U.S. Patent Appln. No.: 10/615,705
Response/Amdt. dated: 03/01/06
Office Action dated: 12/01/05

AMENDMENT OF DRAWINGS (Marked-up Sheets)

FIG. 2

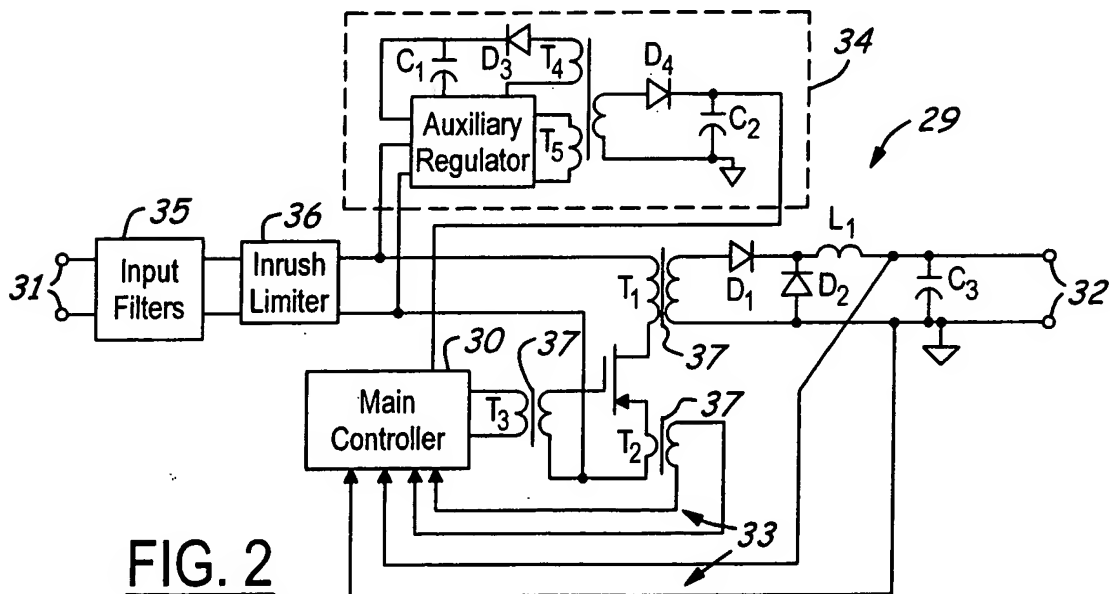
Main Claims 1, 5, 9, 19, and 26, as amended, are now deemed to define the invention subject matter more distinctly so that it can be clearly differentiated from the prior art cited by the Examiner. In the cited Steigerwald U.S. Patent 5,073,848, the "regulator 22" in Fig. 2 is actually an

output rectifier for rectifying the output signal from the switching device stage 17 via isolation transformer 20 (see col. 2, lines 50-52). Likewise, in the Toy U.S. Patent 6,191,500, the feeder breakers of the UPS Module do not act as a non-feedback looped circuit across the plurality of power sources. In the Cuk U.S. Patent 5,570,276, the open-loop sensing circuit (Figure 22) is used for input voltage regulation and not to switch M of N power distribution lines as required for operability of the system. None of the references contain the suggestion to combine all elements from the other references so as to obviate the invention as now more clearly defined.
